# Access Compliance Report

## Public Rights-of-Way

Intersection ID: 2529	Main Street: BAFFIN_CT	Cross Street: BENTGRASS_RUN_DR	Location: E
ADA ID: E400B9D07434	Ramp Type: PerpDiag	Initial Pass/Fail: Fail	Overall Compliance: No
Severity Score: 12.5			
Codes/Mitigation Info/Possible Solution		Field Measurements/Component Compliance

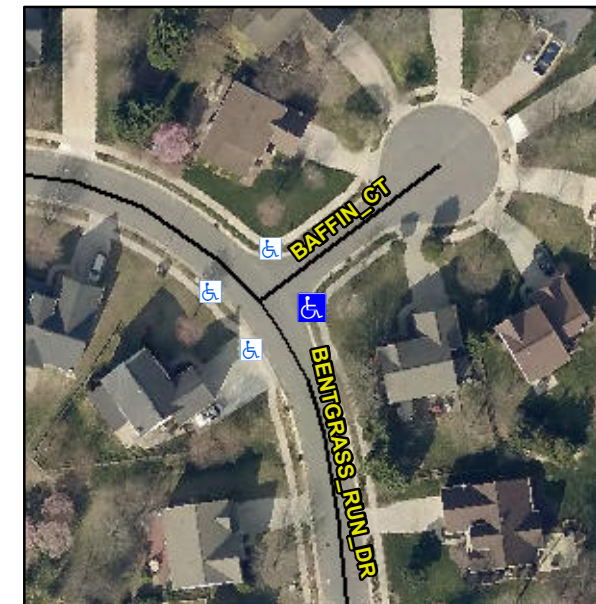
**Not Found, R304.2.2**

Compliance	Description	Data	Compliance	Description	Data
N/A	Ramp Length (in)	47.0	No	Ramp Slope (%)	8.9
Yes	Ramp Width (in)	48.0	Yes	Ramp XSlope (%)	0.7
N/A	Flare Type LT	N/A	N/A	Flare Type RT	N/A
N/A	Flare Slope LT (%)	N/A	N/A	Flare Slope RT (%)	N/A
N/A	Flare Traversable LT?	N/A	N/A	Flare Traversable RT?	N/A
N/A	Landing Length (in)	N/A	N/A	DWS Provided?	N/A
N/A	Landing Width (in)	N/A	N/A	DWS Contrast?	N/A
N/A	Landing Slope (%)	N/A	N/A	DWS Length (in)	N/A
N/A	Landing X Slope (%)	N/A	N/A	DWS Full Width?	N/A
N/A	Landing Curb? (Y/N)	N/A	N/A	DWS Offset (in)	N/A
N/A	Shared Landing?	N/A			
N/A	Gutter Ponding?	N/A	N/A	Gutter Slope (%)	N/A
N/A	Gutter Lip Ht (in)	N/A	N/A	Gutter X Slope (%)	N/A
N/A	Painted X Walk1?	No	N/A	Painted X Walk2?	No
	X Walk 1 Direction	To N		X Walk 2 Direction	To W
N/A	X Walk 1 Width (in)	N/A	N/A	X Walk 2 Width (in)	N/A
	X Walk 1 Slope (%)	3.1		X Walk 2 Slope (%)	2.1
	X Walk 1 X Slope (%)	2.3		X Walk 2 X Slope (%)	3.7

**Remove & Replace Curb Ramp With Two New Directional Ramps or Equivalent.**
